SITE PLAN REVIEW AND APPEARANCE BOARD STAFF REPORT

Drutau Retail

Consideration of a Level 2 Site Plan, Landscape Plan, and Architectural Elevations for the construction of a 1,360 square foot, one-story retail building with associated site improvements, located at 2 NW 18th Avenue.

Below are the original elevations proposed at the August 23, 2023 SPRAB meeting. The new proposed elevations are provided on the right.

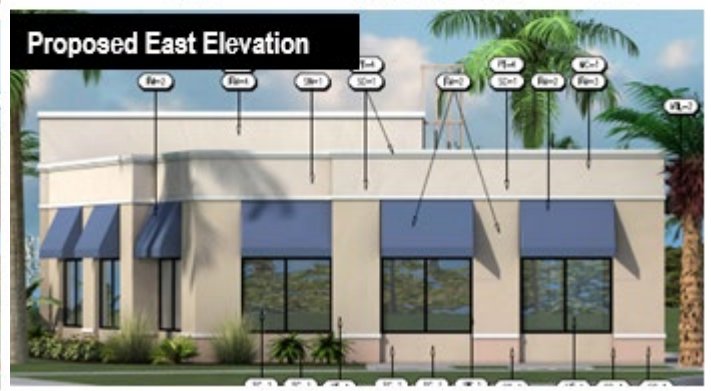
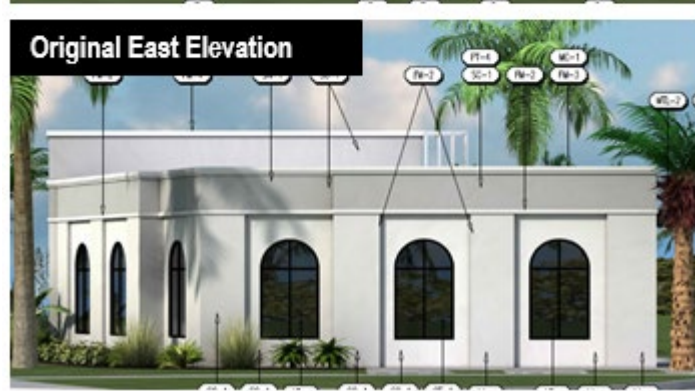
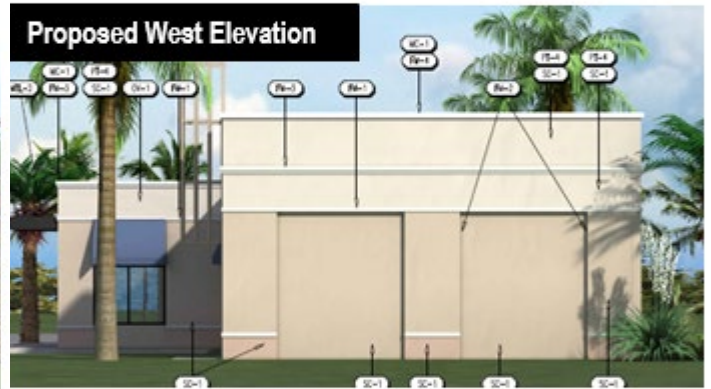
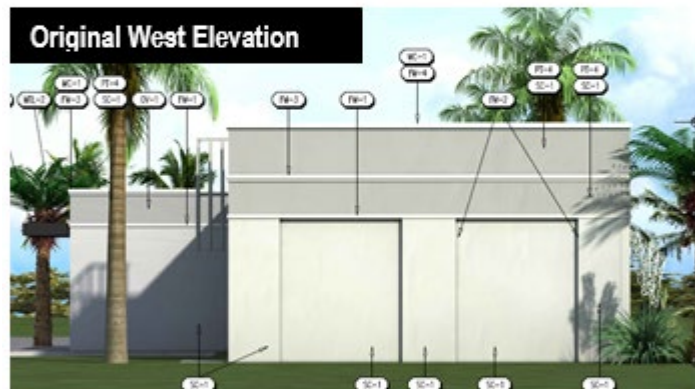
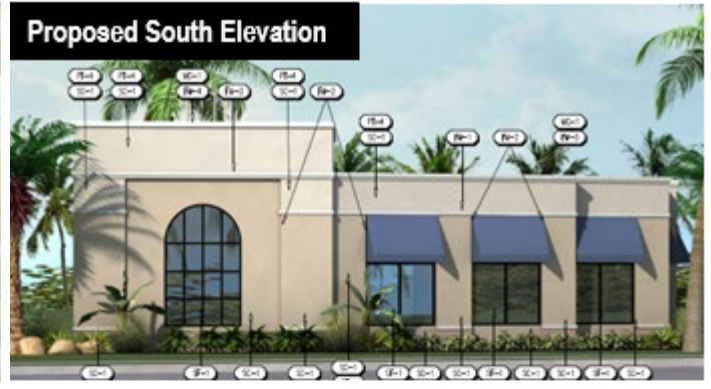
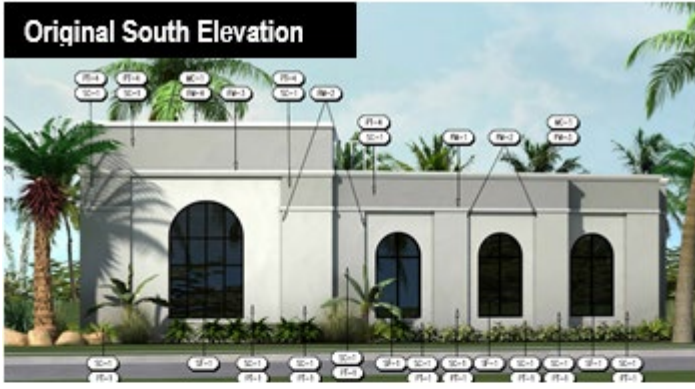
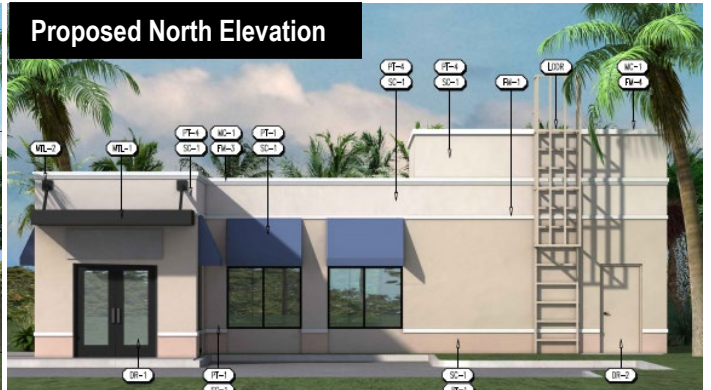
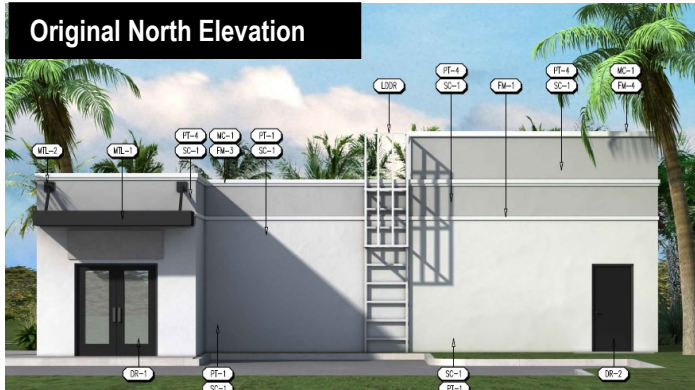
On August 23, 2023, the Board voted 6-0 to continue the item with direction, expressing a desire to see more architectural detailing, a more welcoming color palette, additional window treatment on the north façade to further pronounce the front entrance, and additional treatment to the elevations to create a better-defined storefront. To address the Board’s concerns, the applicant has revised the building’s color palette from a variation of greys to warmer toned beiges, installed blue awnings on the north, south, and east facades, changed most of the half-domed windows to rectangular windows, included additional molding detail at the base of the building, and added window treatments to the north façade.

The Board should consider whether the proposed changes address the Board’s comments from the August 23, 2023, SPRAB meeting, and if the changes help create a defined front entrance and storefront and introduce a color palette that is harmonious with the surrounding development.

- Whether the proposed changes (e.g. updated color palette, addition of awnings and windows, change in window type) address the Board's concerns from the August 23, 2023 SPRAB meeting by creating a defined front entrance and storefront, and introducing a color palette that is harmonious with surrounding development.

The building possesses elements from both the Classical Traditional and Masonry Modern architectural style. A large half-oval window is located on the south façade facing West Atlantic Avenue. Windows have been added to the north façade, which serves as the main entrance point and faces the six-car parking lot. The structure is generally harmonious with the surrounding one-story commercial and light industrial development. Based on the revisions made by the applicant in response to the Board’s comments, consideration should be given as to whether the changes implement proper design elements to reflect the intended retail use and define the main entrance to the building.

A 100.1

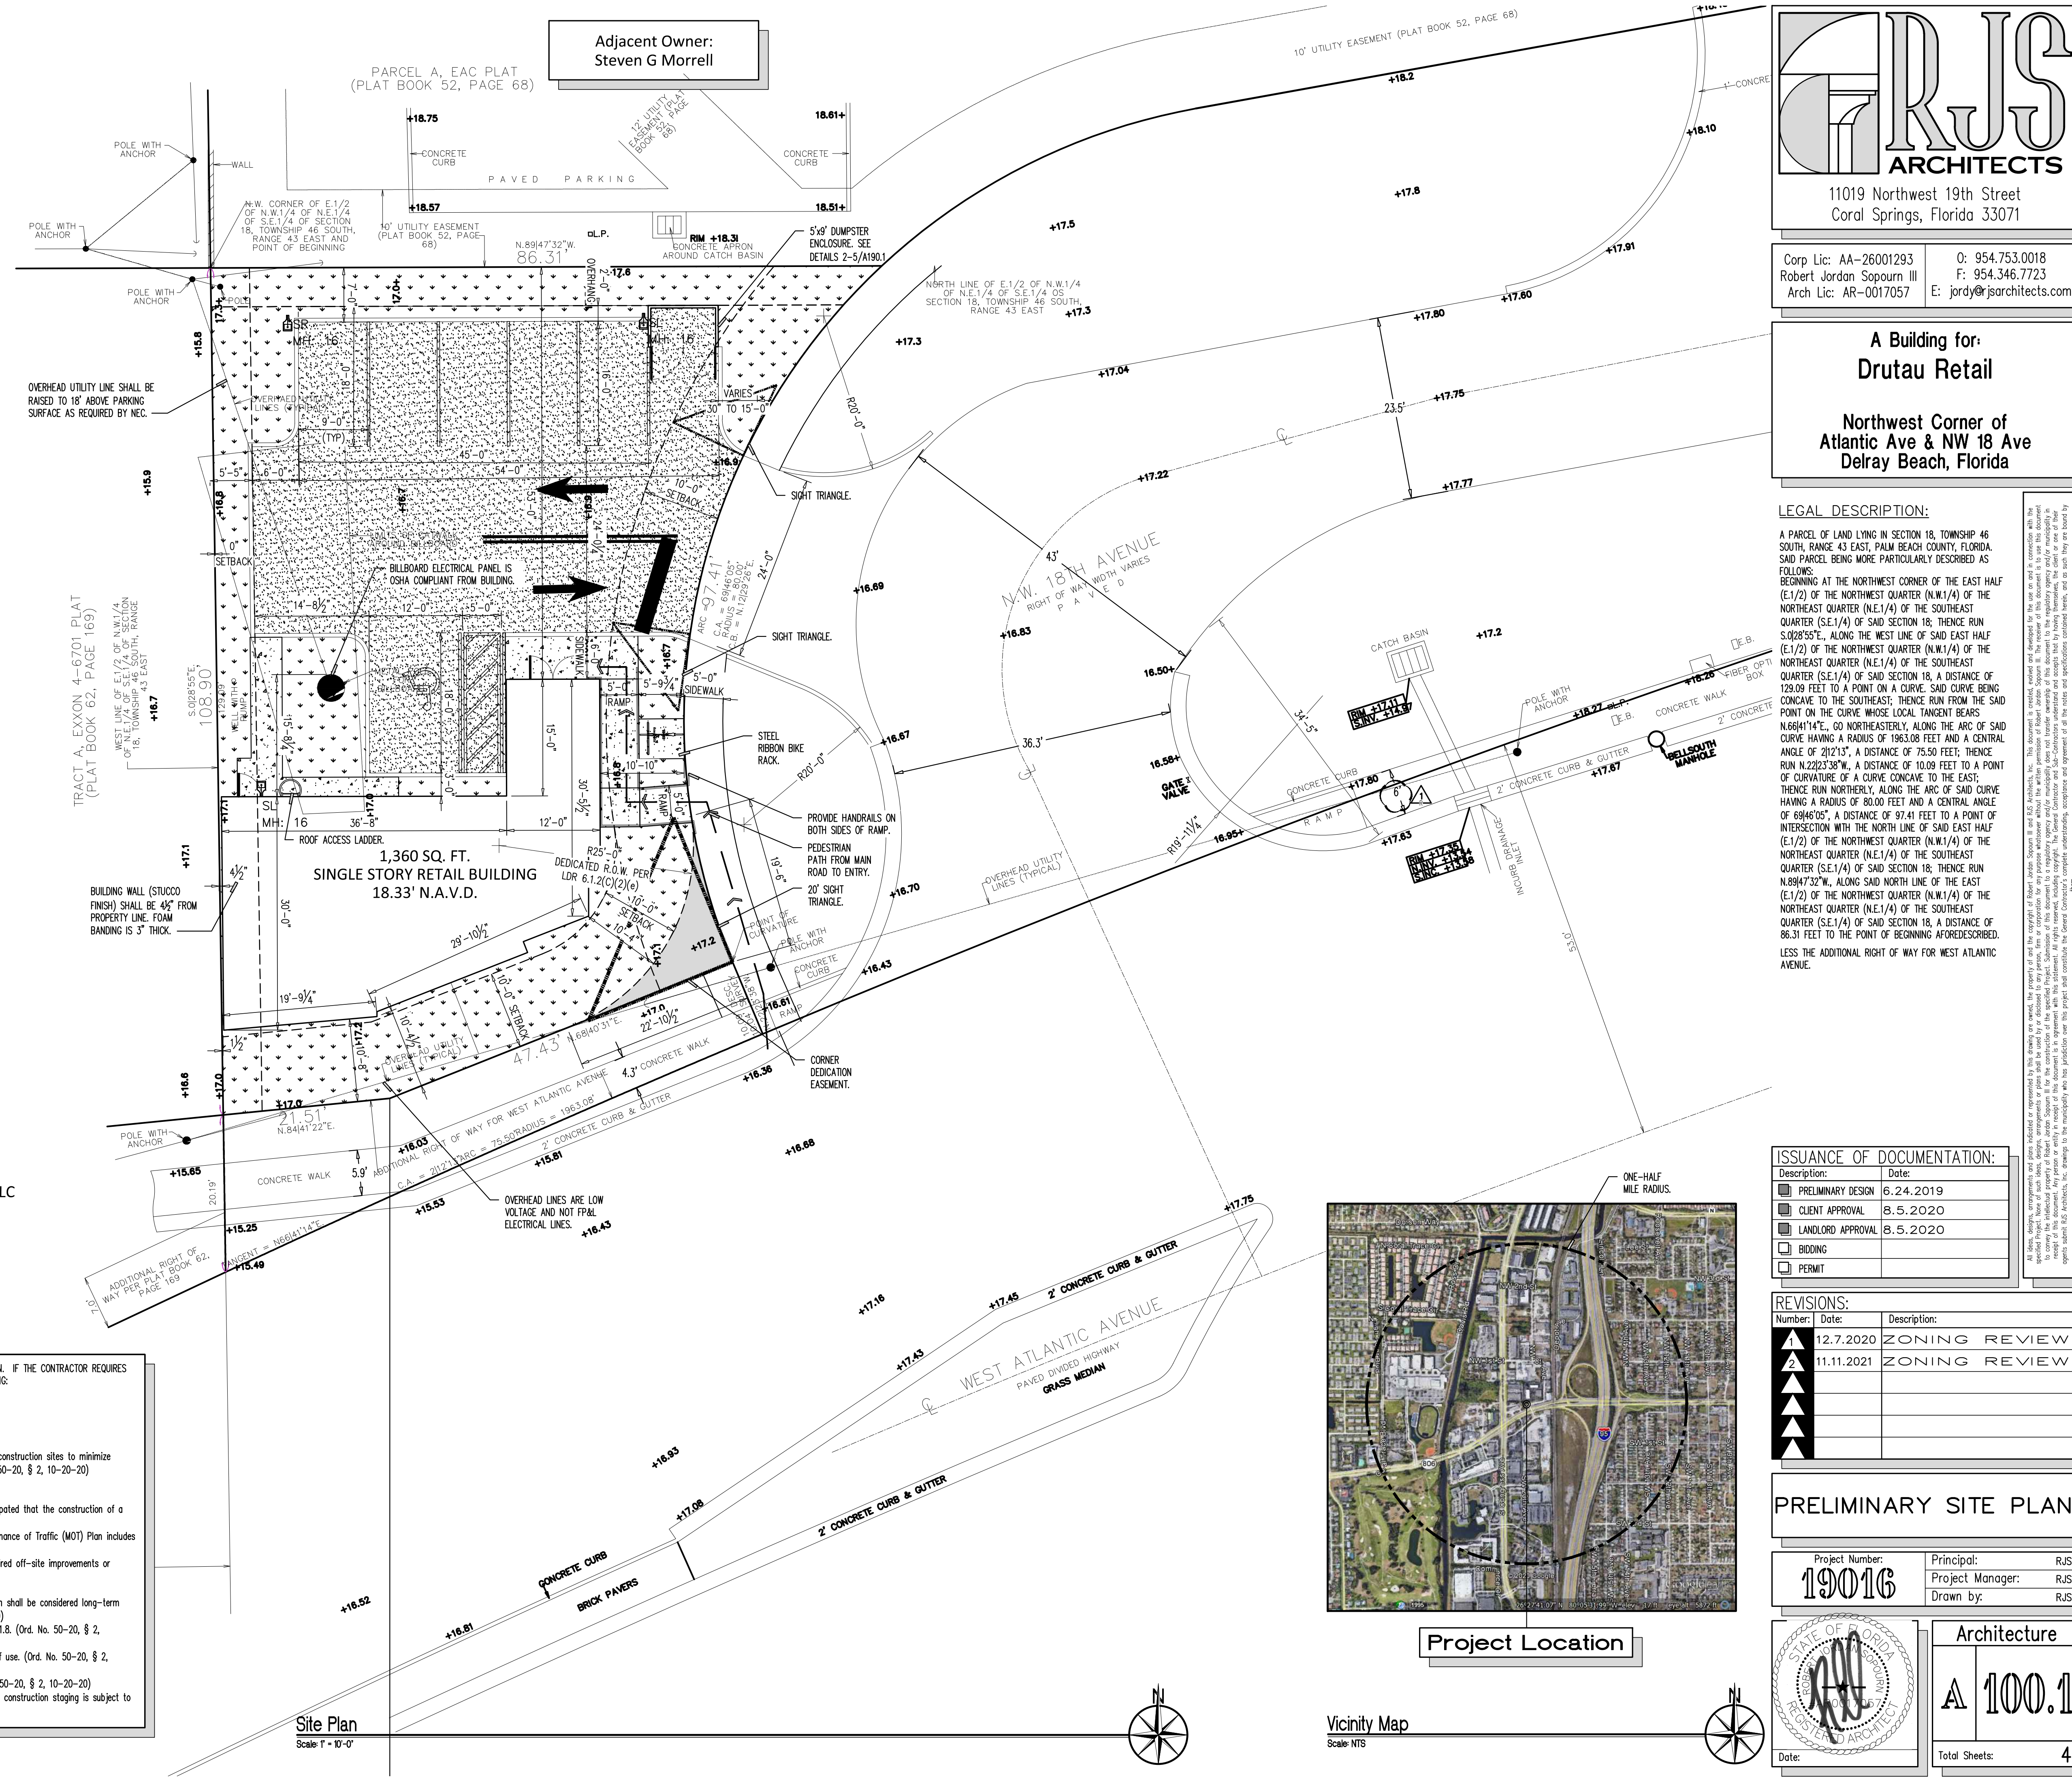
1. Amend the site data table on Sheet A100.1 to reflect the correct rear setback (the site plan dimensions a rear setback of 53 feet, but the site data table lists the rear setback as 53 feet and one-half inches).
2. Provide documentation or note on the plans that all windows will be clear non-reflective glass so that retail merchandise is clearly visible to customers.
3. Provide an updated TPS letter from Palm Beach County, utilizing the most updated trip generation rates.
4. The property owner shall submit a right-of-way deed application to dedicate the 25-foot radius (corner clip) to the City.
5. Record a Minor Plat (boundary plat) pursuant to the procedure in LDR Section 2.4.8(D), Minor Subdivision.
